CITY OF
SAN JOSE
CAPITAL OF SILICON VALLEY

Department of Public Works
TRANSPORTATION AND HYDRAULICS SERVICES DIVISION

ADDENDUM NO. 1
TO
THE PLANS AND SPECIFICATIONS
FOR
UNION/ALMADEN/OAK SANITARY SEWER REHABILITATION

TRENCH BEDDING /BACKFILL AND SURFACE RESTORATION DETAIL (N.T.S.) (REVISED)

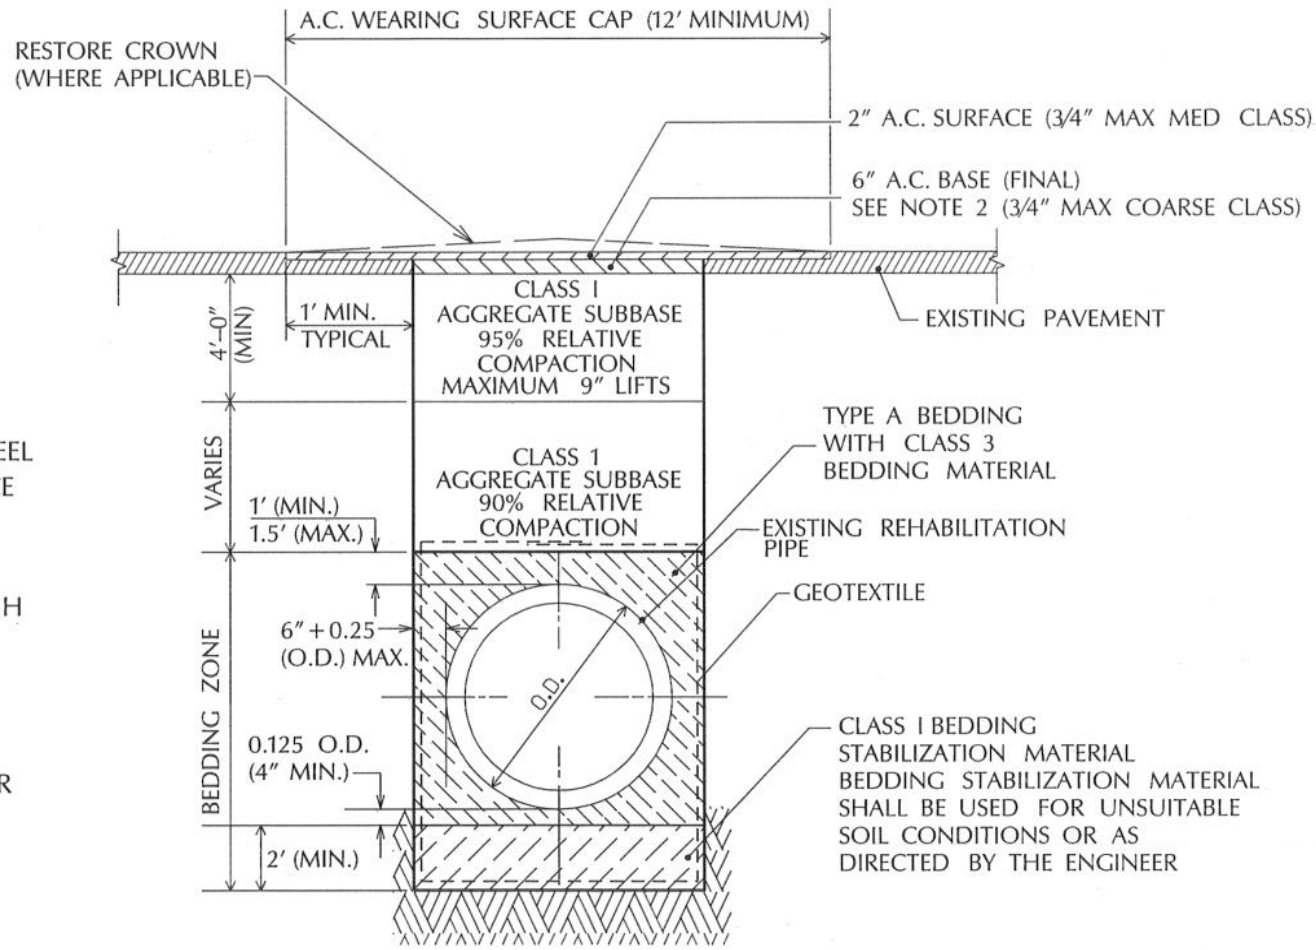
Plan sheet 2 of 10 of the project plans:

DELETE Detail A.

REPLACE with the attached revised Detail A.

TRENCH NOTES

1. CLEAN & TACK SIDES OF EXCAVATION & BETWEEN COURSES WITH SPRAY APPLICATION OF SS–1H BINDER BEFORE PLACING A.C. SURFACE.

2. PLACE A TOTAL OF 6″ A.C. BASE. GRIND ENTIRE WEARING SURFACE CAP WIDTH INCLUDING A.C. BASE & EXISTING SURFACE TO A DEPTH OF 2″ JUST PRIOR TO PLACING A.C. SURFACE. THE 2″ A.C. SURFACE SHALL BE PLACED THE SAME DAY AS THE PAVEMENT GRINDING, OR COVERED WITH STEEL PLATES COUNTERSUNK UNTIL THE A.C. SURFACE CAN BE PLACED.

3. SEAL SURFACE BY SPRAY APPLICATION OF SS–1H EMULSION FOG SEAL AFTER FINISH ROLLING.

4. SHOVEL – SLICING OF BEDDING MATERIAL IN THE HAUNCH AREAS IS REQUIRED WHEN BEDDING IS NO HIGHER THAN THE QUARTER POINT OF THE PIPE.
